# Wisconsin Department of Transportation

**Proposal #18: 1440-15-72**  
**Fond Du Lac – Plymouth**  
**Seven Hills Road – East County**  
**Line**  
**STH 23**  
**Fond Du Lac**

This is Addendum No. 02, which provides for the following:

**ADDENDUM NO. 02**

Addendum No. 02  
 ID 1440-15-72/73  
 Revised Sheet 168  
 March 5, 2020

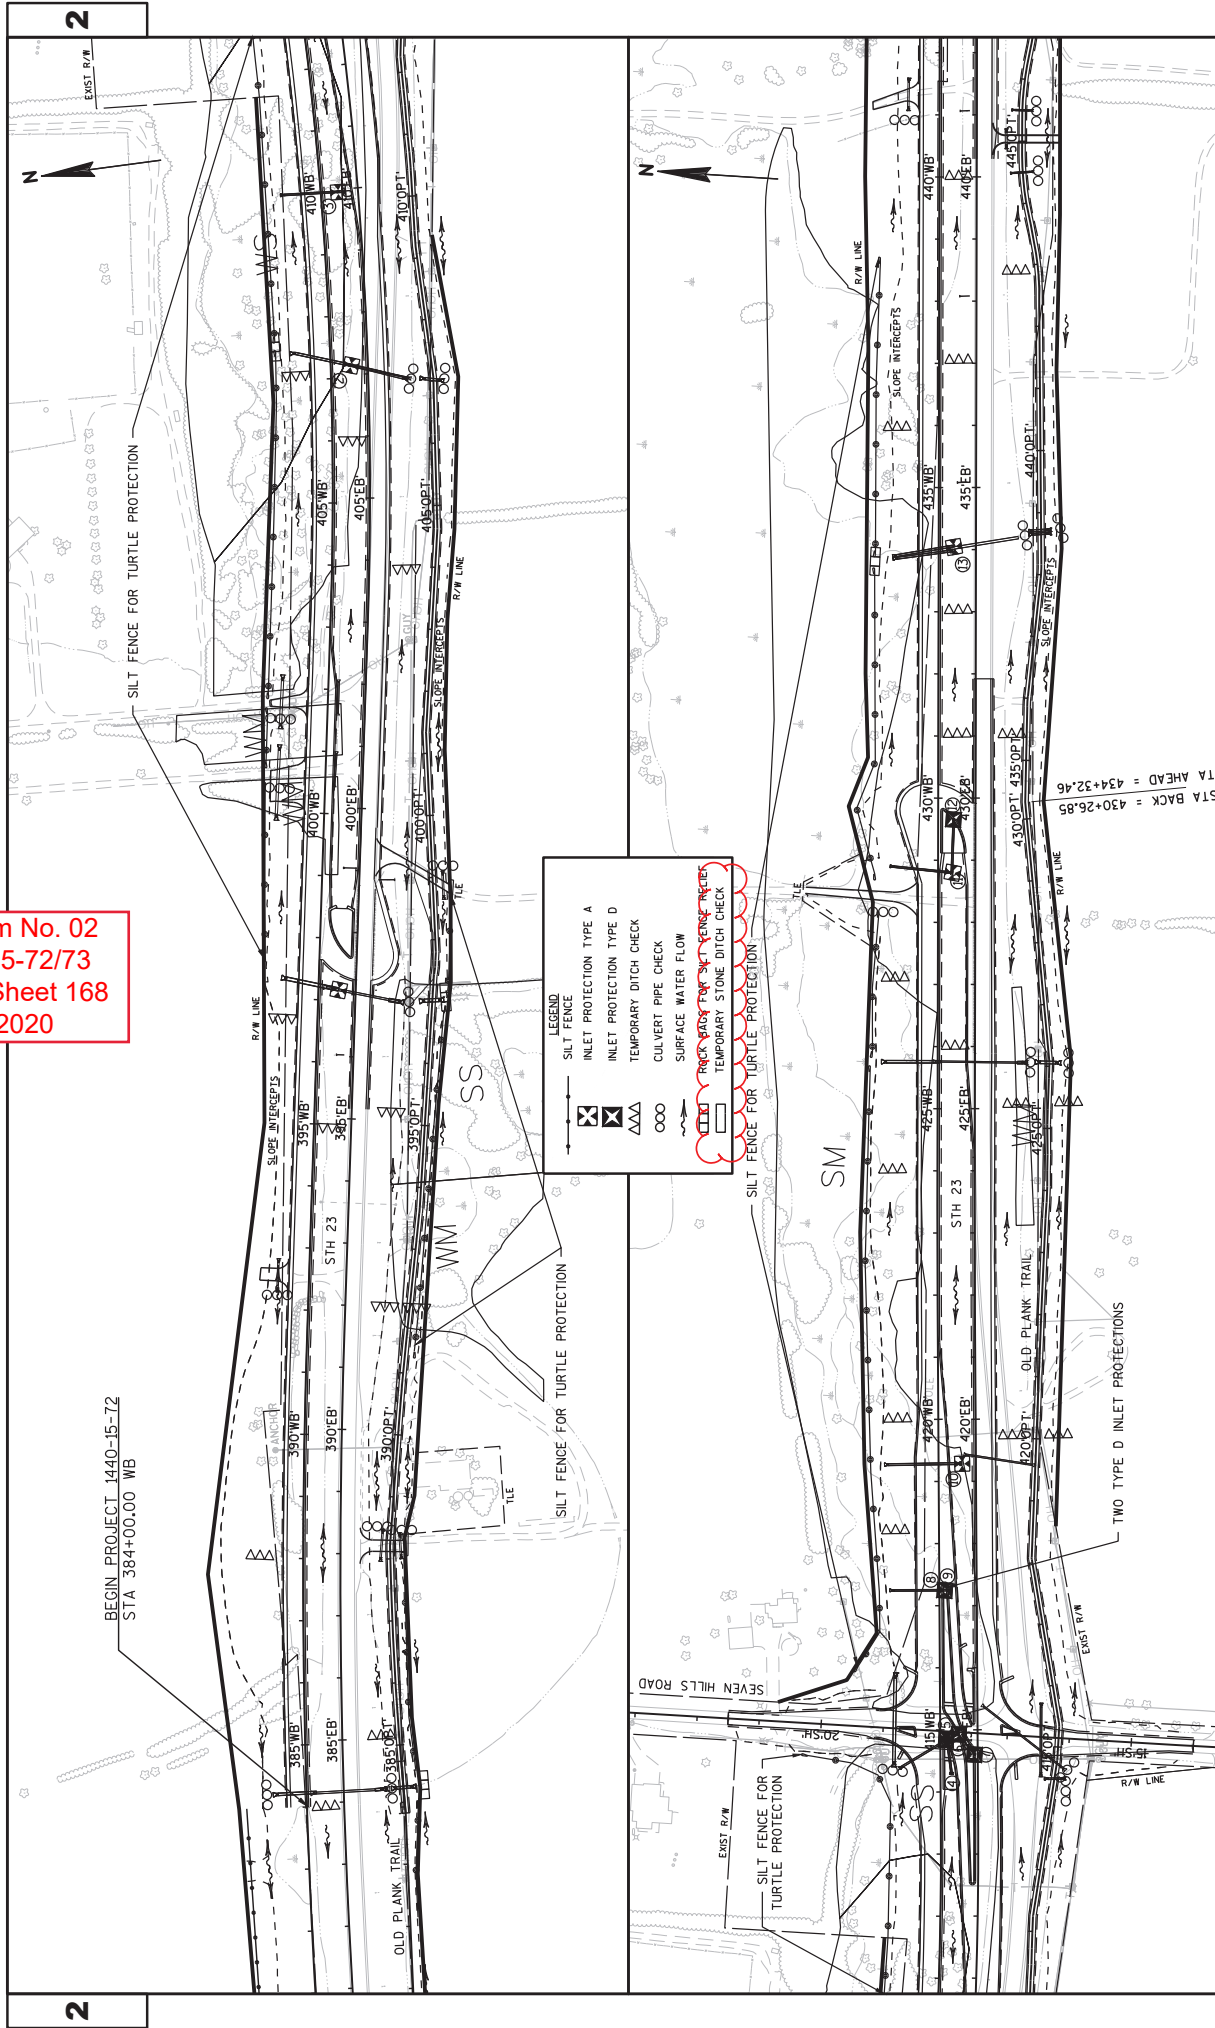
<b>Revised Plan Sheets</b>	
Plan Sheet	Plan Sheet Title (brief description of changes to sheet)
168	Erosion Control – Temporary - Added Temporary Stone Ditch Check symbol to legend
169	Erosion Control – Temporary - Added Temporary Stone Ditch Check symbol to legend and added Temporary Stone Ditch Check symbols to temporary erosion control layout
170	Erosion Control – Temporary – Added Temporary Stone Ditch Check symbol to legend
171	Erosion Control – Temporary – Added Temporary Stone Ditch Check symbol to legend and added Temporary Stone Ditch Check symbols to temporary erosion control layout
172	Erosion Control – Temporary – Added Temporary Stone Ditch Check symbol to legend
173	Erosion Control – Temporary – Added Temporary Stone Ditch Check symbol to legend and added Temporary Stone Ditch Check symbols to temporary erosion control layout
174	Erosion Control – Temporary – Replaced incorrect sheet in plan with correct Erosion Control – Temporary sheet

Addendum No. 02  
ID 1440-15-72/73  
Revised Sheet 865  
March 5, 2020

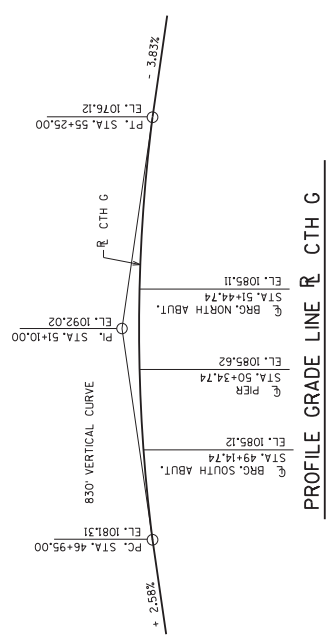
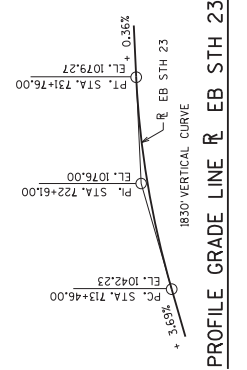
459	Miscellaneous Quantities – Revised quantities at the bullnose terminal
463	Miscellaneous Quantities – Revised quantities for Temporary Stone Ditch Checks
464	Miscellaneous Quantities – Revised quantities for Temporary Stone Ditch Checks
479	Miscellaneous Quantities – Revised note on sheet
865	Structure B-20-218 – Revised unit for item Backfill Structure Type A

NO.	DATE	REVISION	BY
3/2/20		REVISE BACKFILL PAY UNIT	DLW
